U.S. NUCLEAR REGULATORY COMMISSION

Report Nos. 50-206/88-16, 50-361/88-15, 50-362/88-16  
Docket Nos. 50-206, 50-361, 50-362  
License Nos. DPR-13, NPF-10, NPF-15  
Licensee: Southern California Edison Company  
P. O. Box 800, 2244 Walnut Grove Avenue  
Rosemead, California 92770

Facility Name: San Onofre Units 1, 2 and 3  
Inspection at: San Onofre, San Clemente, California  
Inspection conducted: May 22 through July 2, 1988

Inspection Summary

FIGURE 1

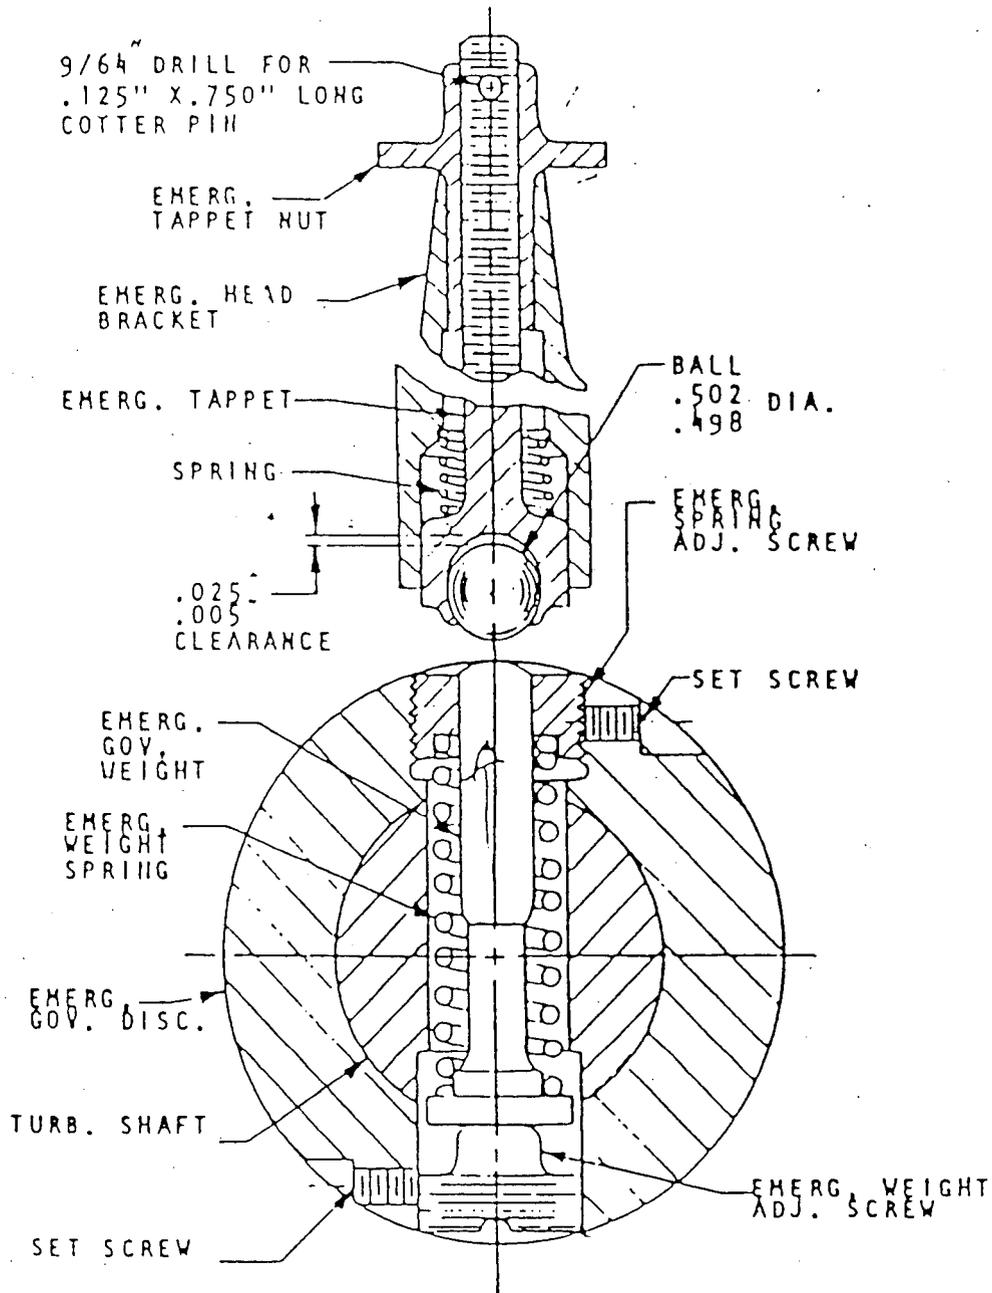
- ° Cause of Turbine Overspeed: Upon loss of power, turbine governor valve 2HV-4700 is designed to fail in the open position to allow for manual control of the turbine. When open indication on valve 2HV-4716 was not received and the technicians disconnected the test power supply, the governor valve failed open, admitting full steam flow to the turbine. The turbine did not trip on mechanical overspeed at 3900 rpm due to a damaged emergency tappet ball (see Figure 1, attached). The ball is made of polyurethane and a piece was missing such that the emergency governor weight could not impact the ball during the overspeed condition. The licensee discussed this condition with the vendor (The Terry Turbine Company) and learned that there have been other occurrences of emergency tappet ball failures. The vendor had changed the design of this part and currently recommends a yearly inspection to verify integrity. The licensee learned that the vendor did not issue any bulletins relative to these changes. The licensee was also considering the resportabilty of this failure pursuant to 10 CFR Part 21.

- ° Stress Analysis: Based on turbine and pump data curves, the licensee determined that the turbine achieved approximately 5000 rpm and pump discharge pressure reached approximately 2400 psig. Based on discussions with the operators, the licensee determined that this condition existed for about one minute. Given these conditions, the licensee determined that piping and component stresses were within ASME Code allowable limits.

Prior to returning 2P-140 to operable status, the licensee took the following corrective actions:

- The turbine casing was lifted and the turbine was visually inspected for damage.
- The auxiliary feedwater pump casing bolts were torqued to verify tightness.

- Portions of the auxiliary feedwater system exposed to 2P-140 discharge pressure were visually inspected, including pipe supports.
- The emergency tappet ball assembly was replaced. The licensee has ordered replacement parts to conform with the vendor's current design and plans to install the new design in Units 2 and 3 upon availability of parts. The emergency tappet ball assembly on the turbine for 3P-140 (Unit 3) was to be inspected prior to returning the unit to service. The licensee will require visual inspection of the emergency tappet assembly annually as recommended by the vendor.

- The turbine overspeed trip device was adjusted and tested. In addition, the licensee was planning to establish a frequency for periodically testing the mechanical overspeed trip device.

FIGURE 2

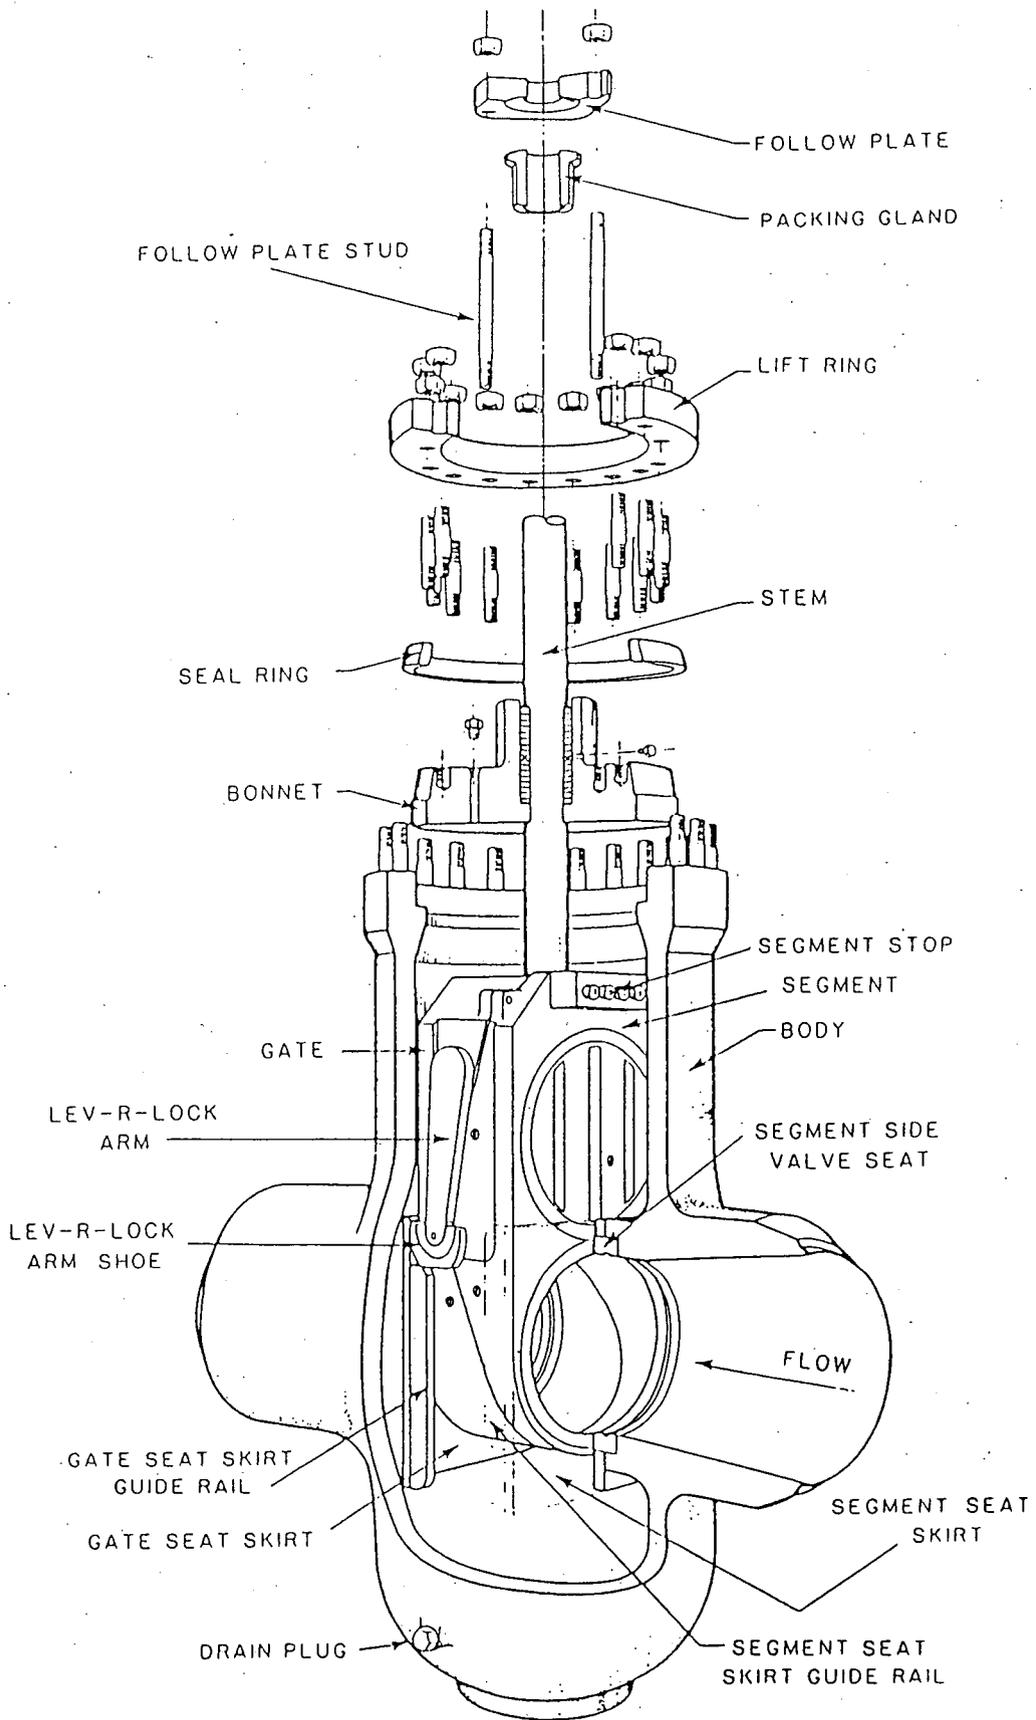
On June 2, 1988, work was being done in accordance with M088030500 to adjust the Limatorque actuator limit switches for shutdown cooling suction isolation valve 3HV-9378. The valve was manually opened and, as the electricians started manually closing the valve to set the open limit switches, the valve became difficult to operate at approximately 10% closed. Nonconformance report (NCR) 3-2002 was initiated to investigate and resolve this condition. Valve 3HV-9378 is a 10" Pow-R-Seal gate valve manufactured by WKM Flow Control Division of Cooper Industries, and is similar in design to (but smaller than) the main steam isolation valves discussed in paragraph 5.d of this report (see Figure 2).

- ° The top capscrew on each guide rail for the gate skirt assembly was sheared off.
- ° The guide rail skirt ("gate seat skirt" in Figure 2) had failed in tension into two pieces. The failure occurred through the second bolt hole from the top of the skirt on each side, where the metal thickness was at a minimum.
- ° The gate guide rails were intact and still bolted to the bottom half of the skirt. The top horizontal and beveled surfaces of the guide rails were severely galled.
- ° The Lev-R-Lock arm shoes were galled on the bottom horizontal surfaces and one shoe was wedged into the Lev-R-Lock arm pivot slot.

The inspector and other NRC representatives questioned whether this hypothesis was supported by conclusive data. Valve stack-up dimensions were not evaluated and free body diagrams were not prepared based on these dimensions. Information provided by the electricians (regarding the amount of torque applied in opening the valve) did not appear to support the licensee's hypothesis. Another hypothesis discussed with the licensee was that the valve had failed during normal operation due to excessive tolerances and valve design (e.g., guide rail chamfer).

Although the licensee's corrective actions appeared to be appropriate, the inspector questioned whether Station management had required a sufficiently rigorous technical evaluation during the early stages of problem resolution (e.g., before core reload). As a result, licensee personnel missed opportunities to recognize incipient failure of 3HV-9378. Specific observations associated with resolution of the NCR were as follows:

- All defective components associated with 3HV-9378 were replaced with qualified spare parts.
- Procedures were changed to limit the amount of travel allowed when manually opening this type of valve.
- Additional MOVATS testing was conducted on other shutdown cooling suction isolation valves to confirm that anomalies did not exist in the current traces.

As long-term corrective action, the licensee was evaluating the need for design changes to the WKM Pow-R-Seal gate valve.
